**Subject: Submittal of the Response to the Notice of Disapproval for the Vadose Zone Subsurface Characterization and Vapor Monitoring Well Installation Work Plan for Material Disposal Area V, Consolidated Unit 21-018(a)-99 and Revision 1**

**Response to the Notice of Disapproval for the Vadose Zone Subsurface Characterization and Vapor-Monitoring Well Installation Work Plan for Material Disposal Area V, Consolidated Unit 21-018(a)-99 Los Alamos National Laboratory, EPA ID #NM0890010515, HWB-LANL-06-021  
Dated July 24, 2009**

**Vadose Zone Subsurface Characterization and Vapor-Monitoring Well Installation Work Plan  
for Material Disposal Area V, Consolidated Unit 21-018(a)-99, Revision 1**

Figure 1 Location of borehole 21-24524 at MDA V

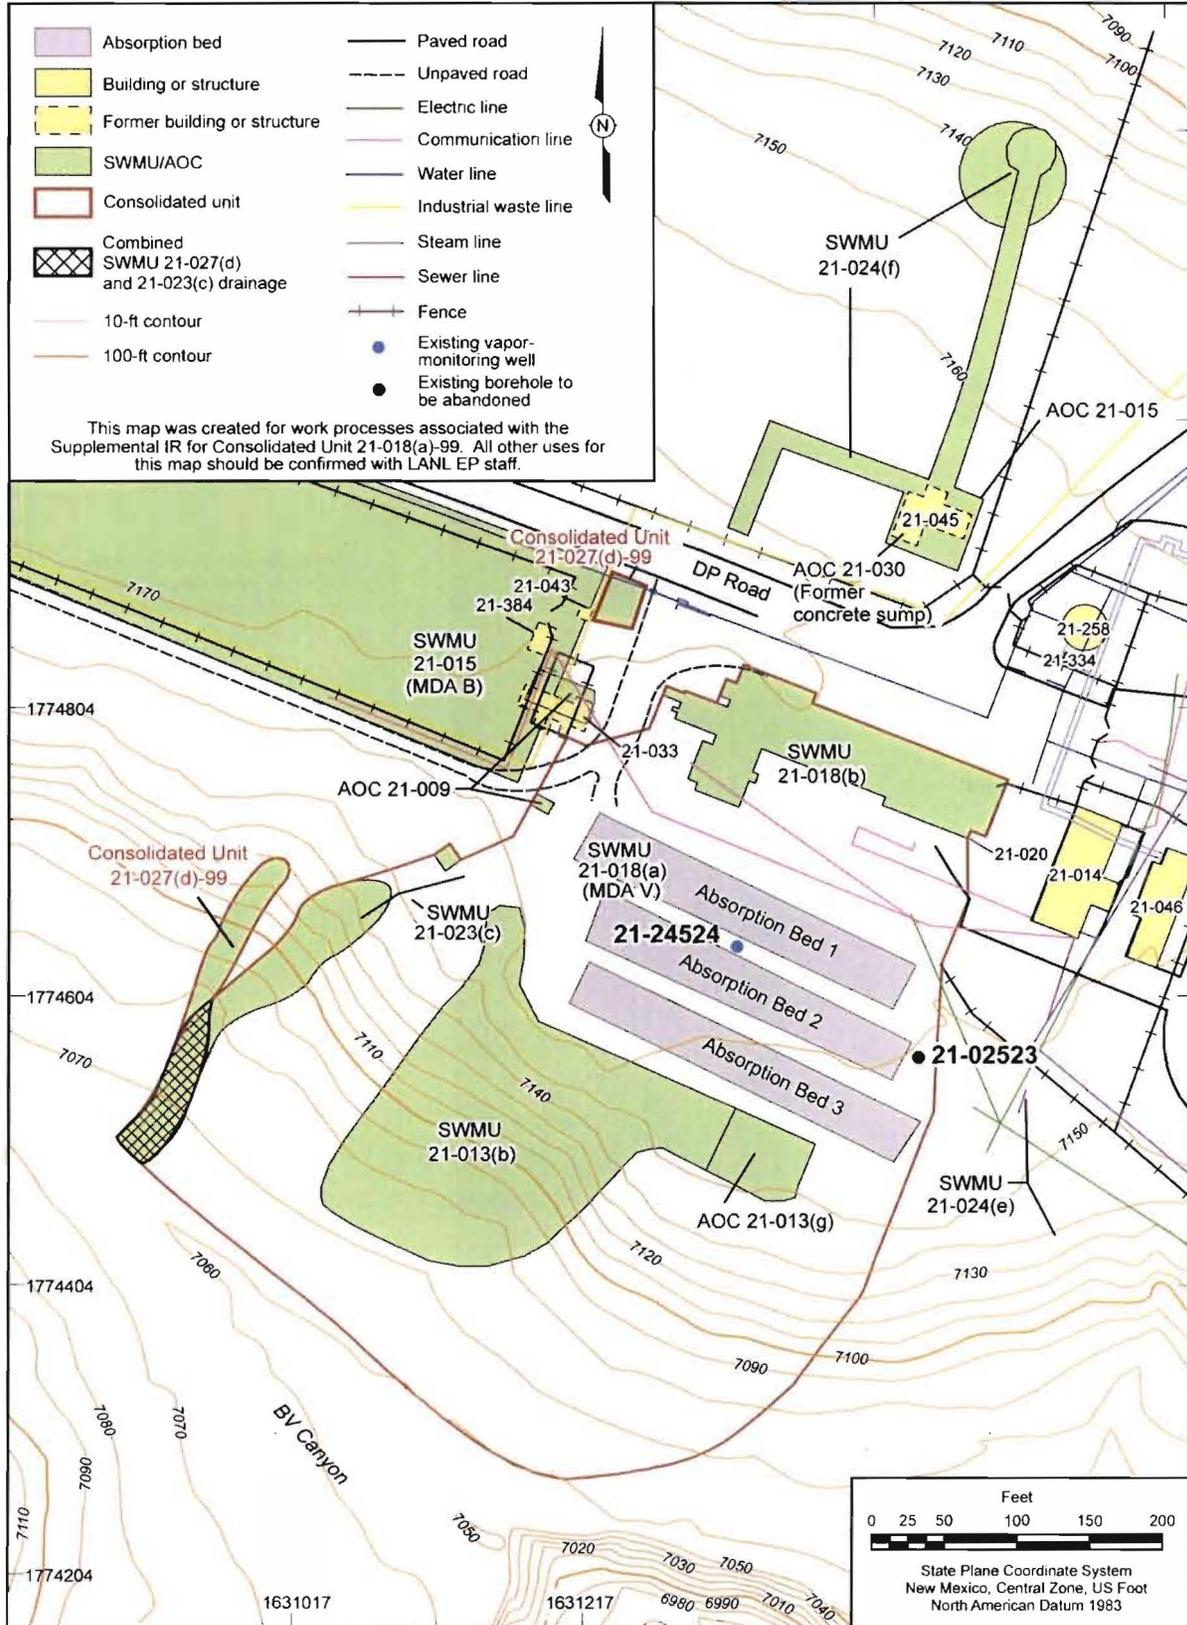
*Additionally, the Permittees must revise Figure 1 to include the location of borehole 21-02523.*

2. Figure 1 has been revised to include the location of borehole 21-02523.
